DEVELOPMENT REVIEW BOARD REPORT

Cavasson Retail 6-DR-2020	Request by owner for approval of a site plan, landscape plan and building elevations for a new single-story, 15,000 square foot commercial shell building, designed to accommodate retail/restaurant uses, located on a +/- 5-acre site at the northwest corner of Hayden Road and Loop 101.
--	--

6-DR-2020

1 SITE DEVELOPMENT PLAN
SCALE: 1" = 20'-0"

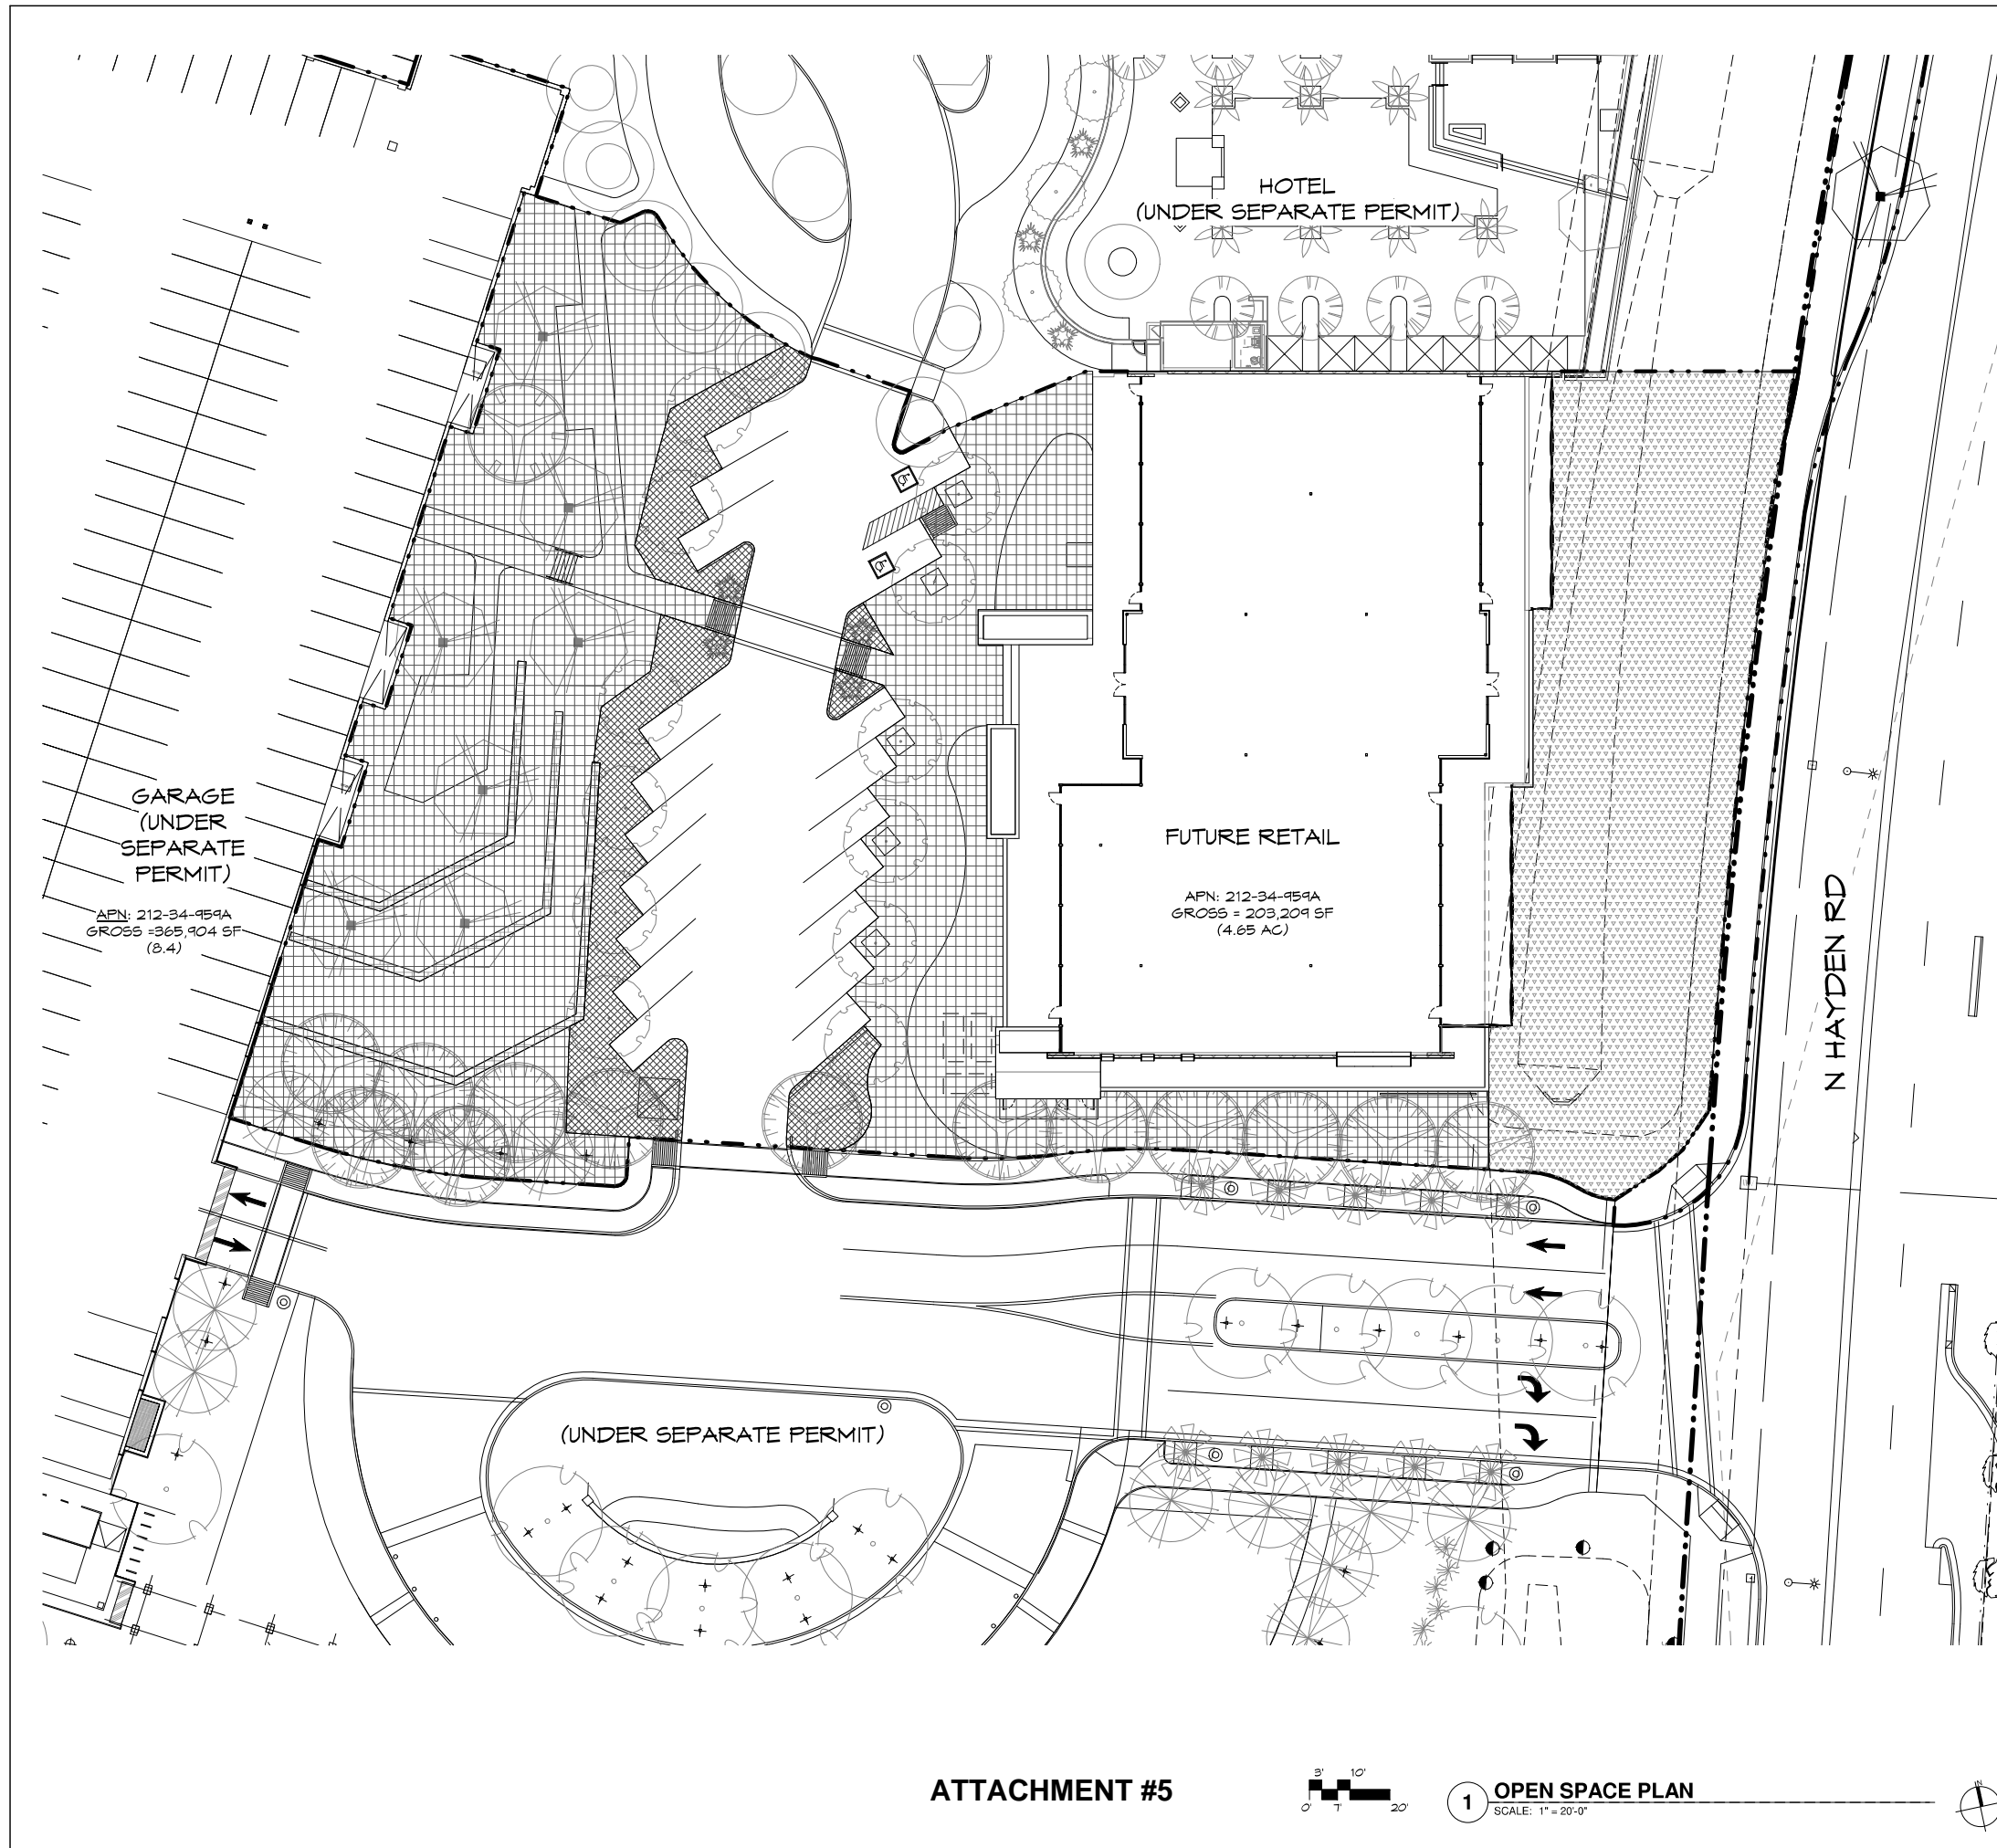
- Staff finds that the site design emphasizes the pedestrian realm by providing wide and plentiful sidewalks and plaza spaces. While the parking garage is not immediately adjacent to the building entrance, sidewalks are placed to provide the most direct route to the building entrance from the garage, and crosswalks consisting of custom pavers are provided to clearly delineate connections that cross the driveway.

- b. The location and configuration of all site improvements shall be consistent with the site plan provided by Butler Design Group, with a city staff date of 5/19/2020
